Re: Petition No. 1247 - C-TEC Solar, LLC petition for a declaratory ruling that no Certificate of Environmental Compatibility and Public Need is required for the proposed construction, maintenance, and operation of a 3.75 MW solar photovoltaic electric generating facility located at 1 Ballard Road, Thompson, Connecticut

Below you will find our responses to the Connecticut Siting Council Interrogatories date December 21, 2016. Additionally, enclosed please find a copy of the cover letter submitted to the Town of Thompson and a copy of DN-1 with the modified fence detail.

DETAIL SHEET

DN-1

4 CHAIN-LINK FENCING DETAIL
SCALE : N.T.S.

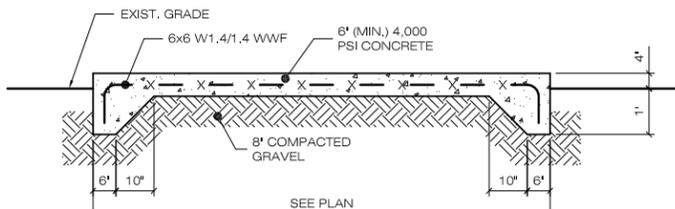
10. *Sheet DN-1 of the Phase II D&M Plan shows a gap of up to 1.5 inches under the proposed fence. Would there be any wildlife protective value associated with elevating the bottom of the fence surrounding the solar array and the equipment compound) by roughly size inches above grade in order to allow wildlife such as turtles to pass though and reduce the risk of entrapment? Explain. If yes, could such a gap (or different size gap as recommended) be accommodated?*

Answer: There could be some wildlife protective value associated with elevating the bottom of the fence by approximately 6 inches above existing grade to allow for wildlife passage. C-TEC has revised their fence detail to include a 6-inch gap, see attached.

3 TYPICAL POST MOUNTED RACKING SYSTEM
SCALE : N.T.S.

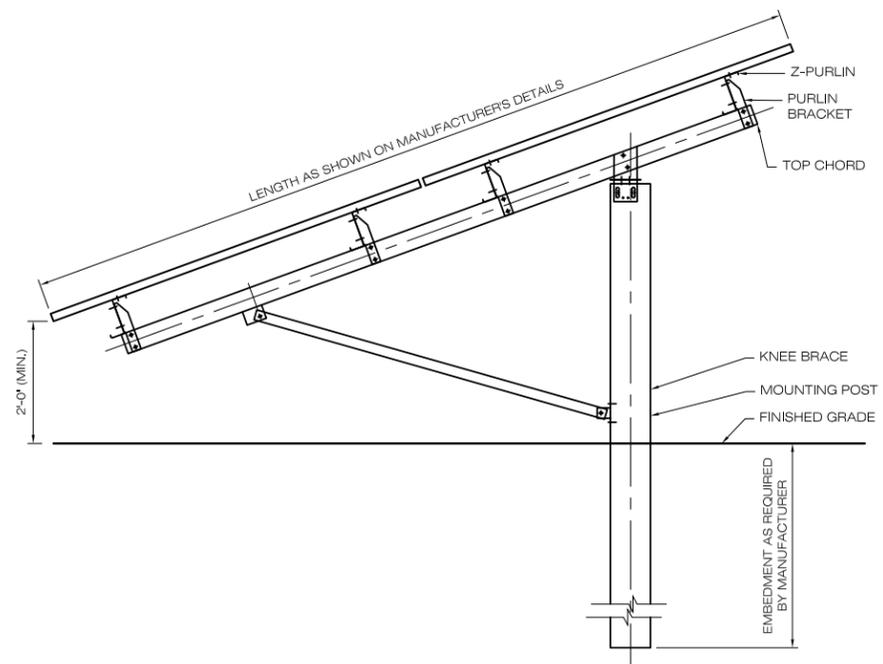
4. *Sheet DN-1 of the Phase II D&M Plan does not include the angle of the solar panels with the horizontal or maximum height of the panels. Based on the Council staff report for Petition No. 1247, the top of the solar panels would be approximately 7-foot 10-inches and the oriented at 25 degrees above the horizontal. Are these specifications still correct? If no, please update.*

Answer: These specifications are still correct.
